Planning and Zoning Commission Special Meeting AGENDA

STAFF REPORT
KETCHUM PLANNING AND ZONING COMMISSION
SPECIAL MEETING OF JANUARY 26th, 2021

- PROJECT:** Warm Springs Ranch
- FILE NUMBERS:** P 21-001, P21-002, P21-003 & P21-010
- APPLICATION TYPES:** Development and Rezoning Agreement, Subdivision Preliminary Plat, & Floodplain Development
- REPRESENTATIVE:** Kurt Eggers, Eggers Associates, P.A.
- PROPERTY OWNER:** Robert Brennan, Brennan Holdings No 300 LLC
- LOCATION:** Warm Springs Ranch Resort PUD Blocks 1-8, 1803 Warm Spring Road
- ZONING:** Tourist (T) and Recreation Use (RU)

WARM SPRINGS RANCH WORKSHOP: PLANNING AND ZONING COMMISSION REVIEW

EXHIBIT H
TENT DIAGRAM, DRAWING A.6

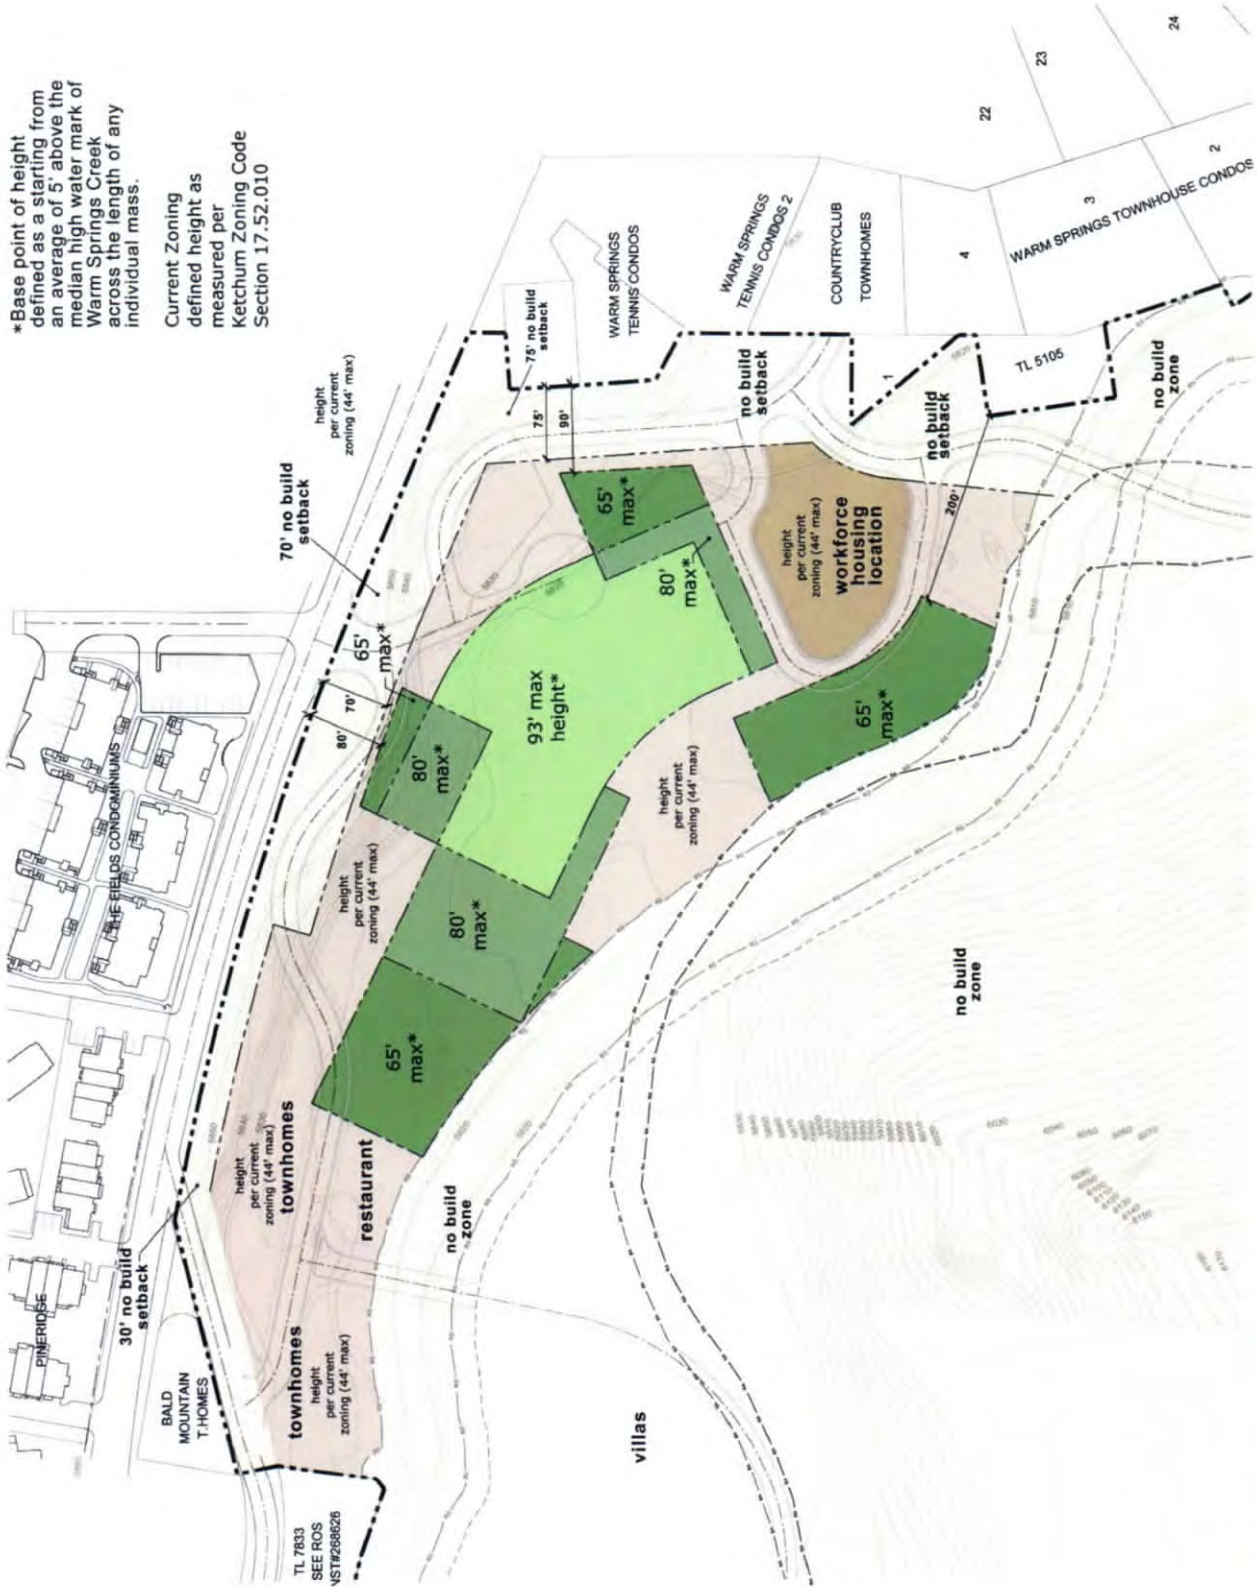
D. Building Height. Building height and height location shall be restricted by the Tent Diagram, Drawing A.6, titled Development Height Standards. Exceptions to height limits are as follows:

E. Building Height Area Restrictions. The building mass shall be restricted within the illustrated building envelope boundaries shown on the Tent Diagram, Drawing A.6, titled Development Height Standards, at different elevations by the following standard:

GRADING & DRAINAGE PLAN
WARM SPRINGS RANCH: BLOCK 1
T4N, R17E, SEC 12, B.M., CITY OF KETCHUM, IDAHO
PREPARED FOR: BOB BRENNAN

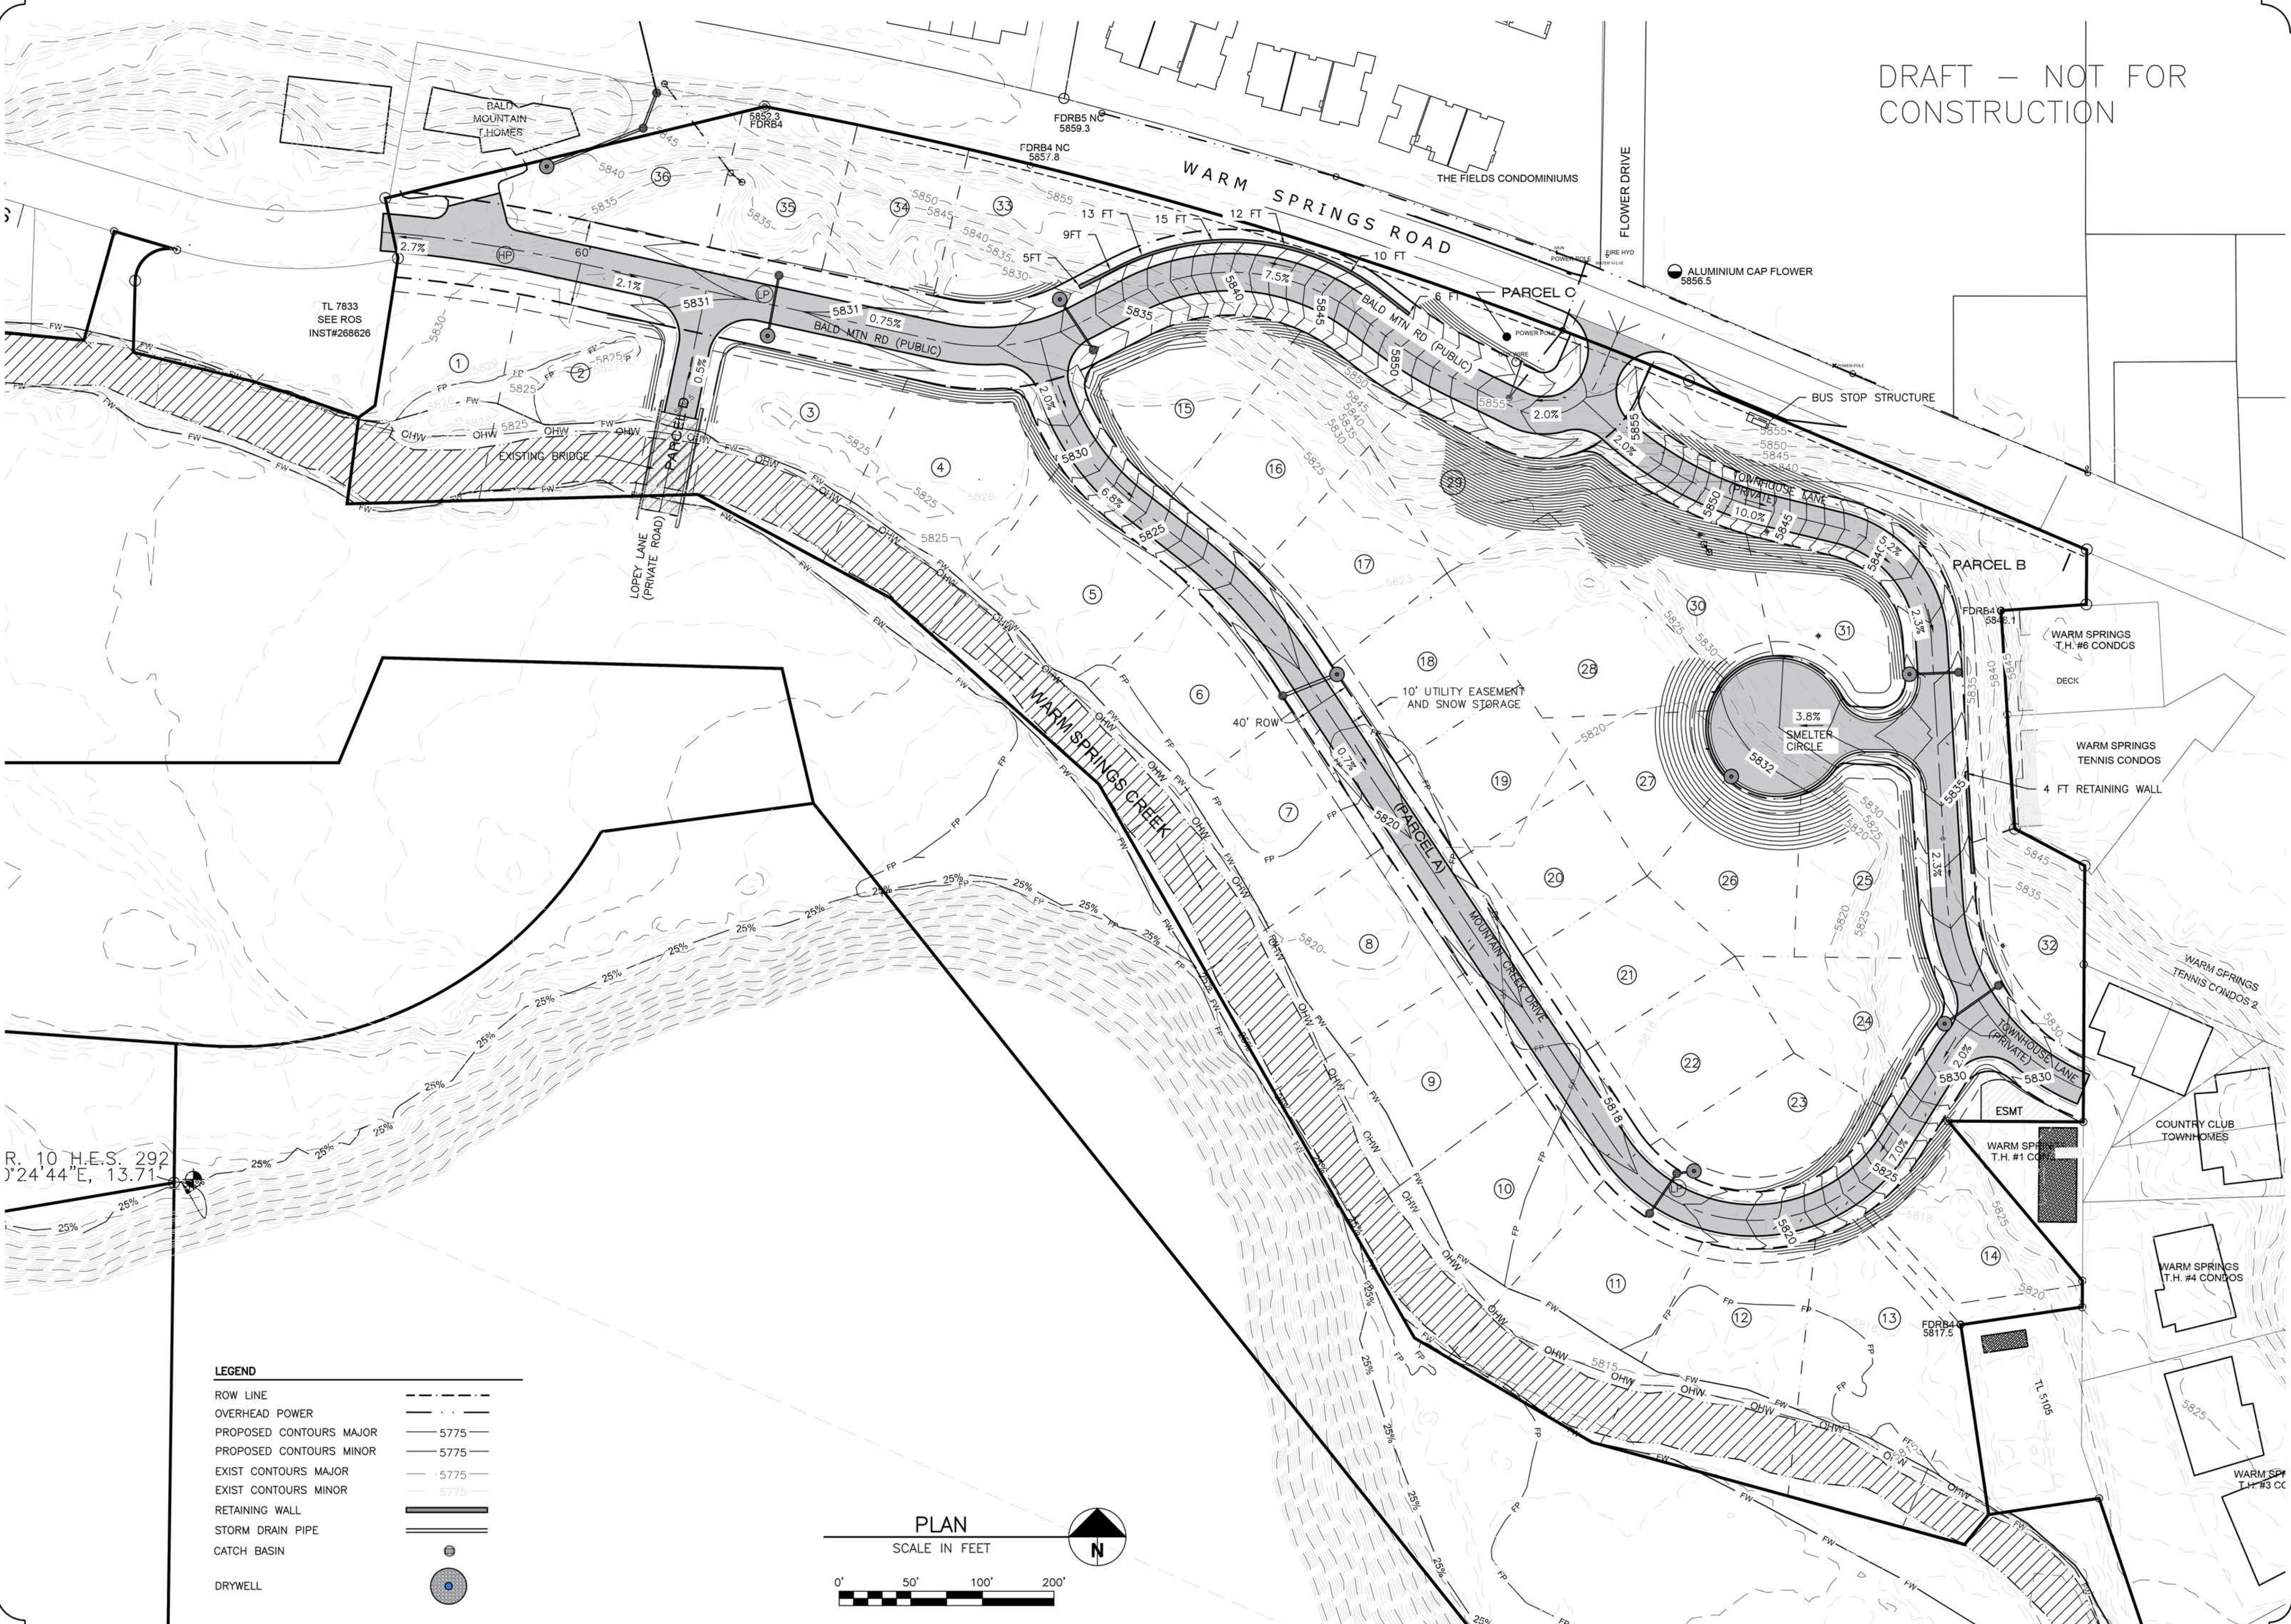
Drainage within the residential subdivision will be managed through a system of swales, catch basins, and drywells. The grading and drainage plan is indicated on Sheet C-2 of the project plans (Attachment C).
